Title : POLARIS/D009P1	
Engineer: Amey_Liu	
Doc No: D009P1	Rev: 1.00
Doc No: D009P1	Rev: 1.00

ASUS		Title : POLARIS/D009PI	
PCB Designer		Engineer: Anney_Liu	
Rev	Project Name	Rev	
0001	D009PI	0001	1.00
Date: 2024-06-05 10:00:00		Page: 31 of 38

(7) ELLESMERE GPIO STRAP CF XTAL

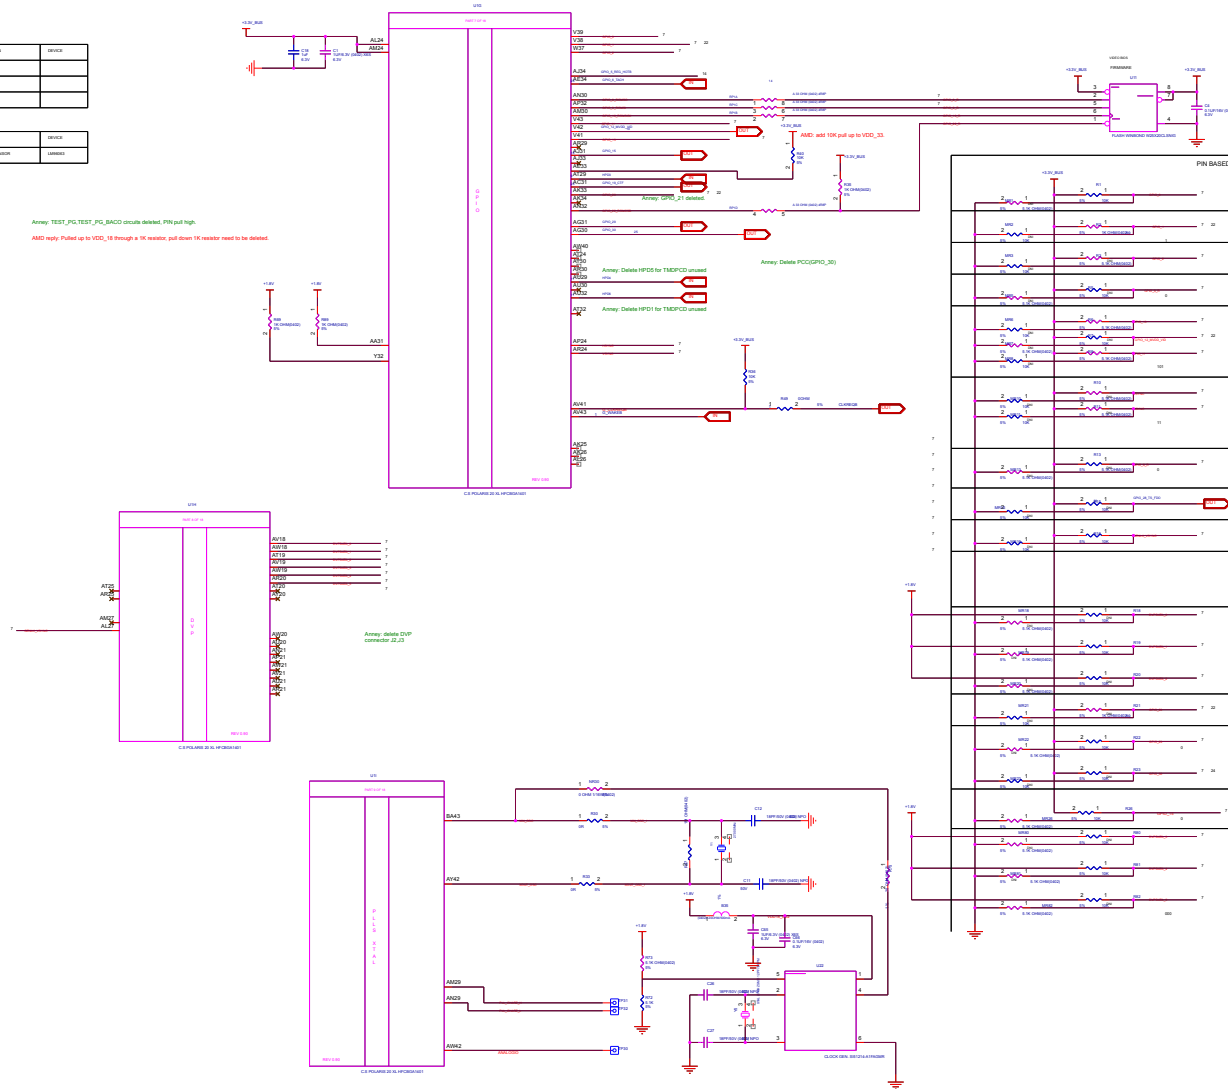
AMD reply: Pulled up to VDD_{IO}18 through a 1K resistor, pull down 1K resistor need to be deleted

(10) ELLESMERE TMDPCD unused

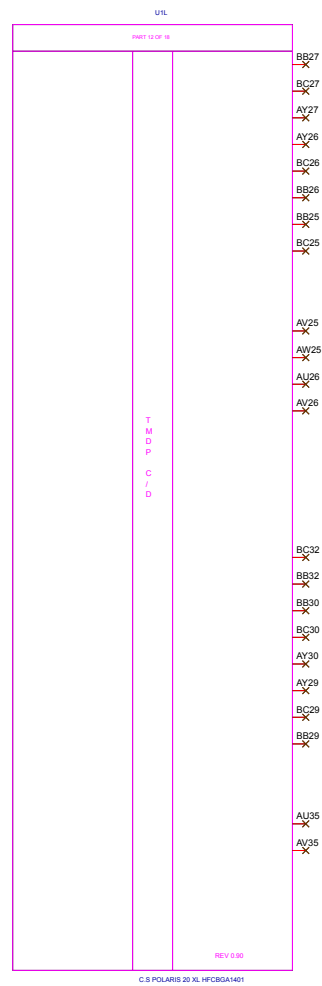
Anney: TMDPCD unused, all pins NC

(24) DEBUG CIRCUITS

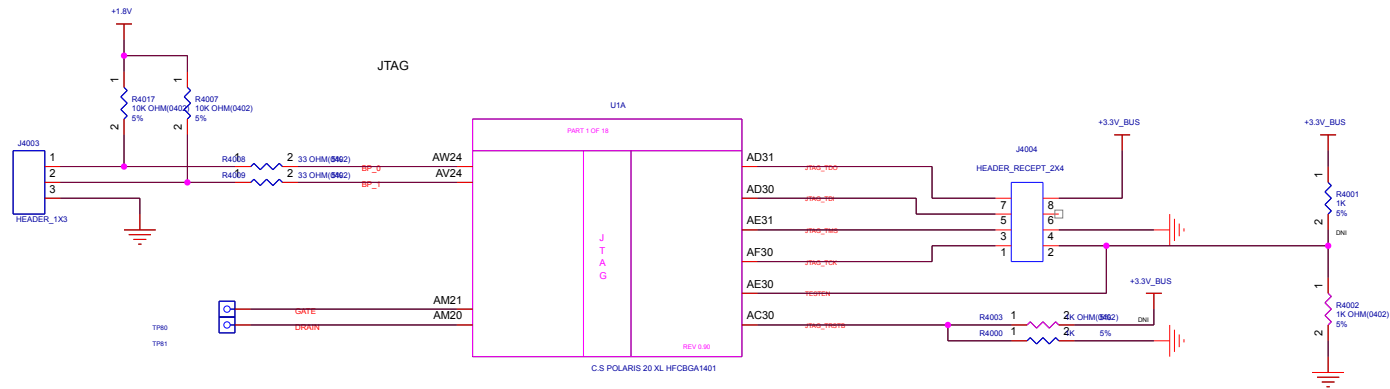
Anney: EVDDQ Debug E-fuse deleted
